# Technical *Info*

## Retooling the tensioning technology in the Ford 1.8 diesel ( CT 983 K1/K2 )

**Fig. 2**  
**New tension pulley technology**

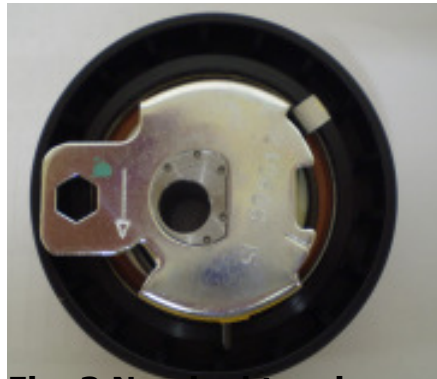
The tensioner pulley in the kit is designed technically differently from how it is installed at the factory.

According to Ford, the new type of tension pulley has to be installed in all 1.8 diesel engines when the timing belt is due to be changed. Given the fact that the structure has been changed completely, clarification is required on how to install or position this correctly.

The new type is a semi-automatic tension pulley which is installed centrally in place of the manual tensioner (50 Nm). Following installation of the timing belt, as normal, the tension is adjusted on the disc on the front by turning it in the imprinted direction of the arrow using an Allen key. Make sure that the recess is opposite the stop lug in approx. 3:00 position. In some older versions, the cover must be filed by a few tenths of a millimeter in the area of the tensioning roller.
